RE: **Percolation Testing Report**
1723 Underwood: Tax Map 9: Parcel 300
Sykesville, MD 21784

RE: **Building Permit #B21001433**

RE: **Percolation Certification Revised Plan**
1723 Underwood: Tax Map: 9 Parcel 300

Subject: Percolation Certification Revised Plan
1723 Underwood: Tax Map: 9 Parcel 300

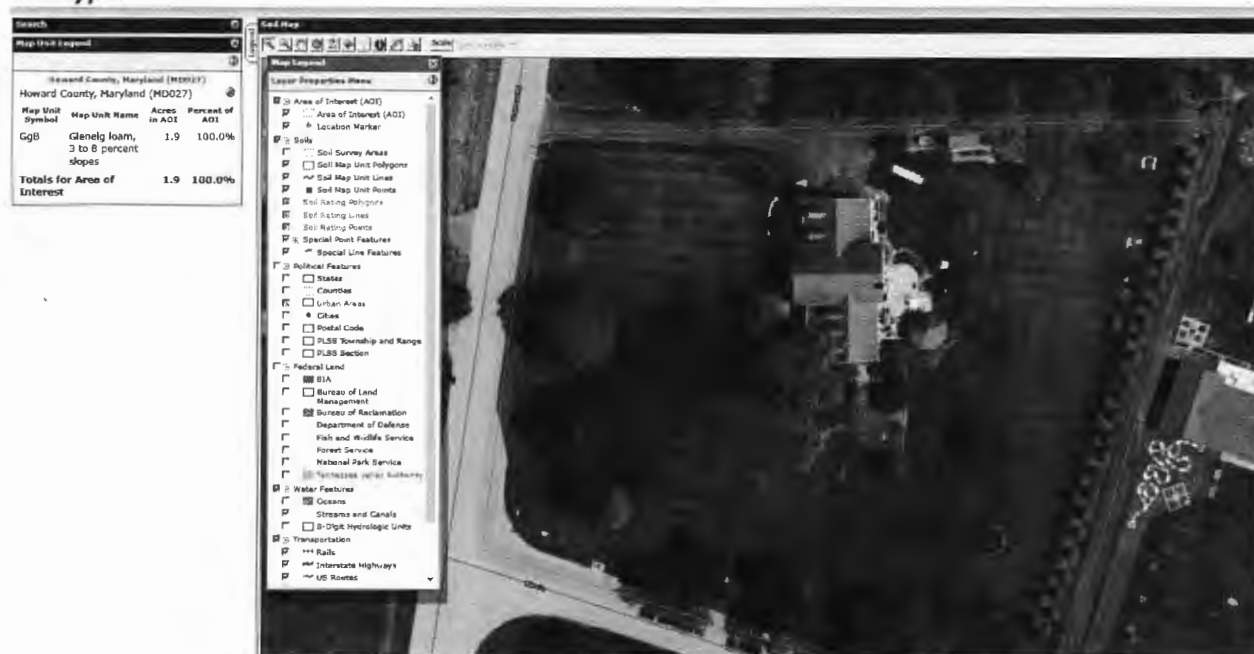
- If the lot was created AFTER March 1972 a minimum area of 10,000 sq. ft. is required as designated septic reserve area. For lots created PRIOR to March 1972 a septic reserve area large enough to accommodate 3 systems (an initial and 2 replacements) must be proposed. When 3 systems are proposed calculation must be shown on plans for confirmation. I have included septic specs to help with calculations. (see attached)

Response: Please see Sheet S-3 indicating 10,000 sf septic area. Calculations are provided on Sheet S-2.

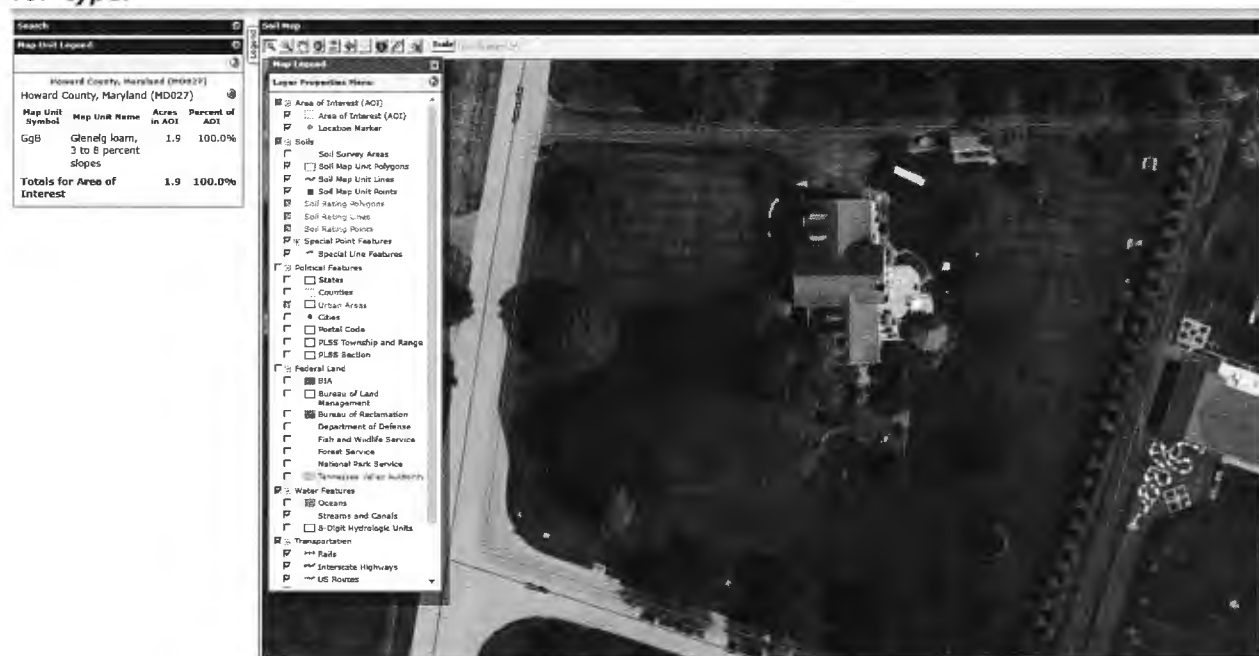
- If the lot was created AFTER March 1972 a minimum area of 10,000 sq. ft. is required as designated septic reserve area. For lots created PRIOR to March 1972 a septic reserve area large enough to accommodate 3 systems (an initial and 2 replacements) must be proposed. When 3 systems are proposed calculation must be shown on plans for confirmation. I have included septic specs to help with calculations. (see attached)

Response: Please see Sheet S-3 indicating 10,000 sf septic area. Calculations are provided on Sheet S-2.
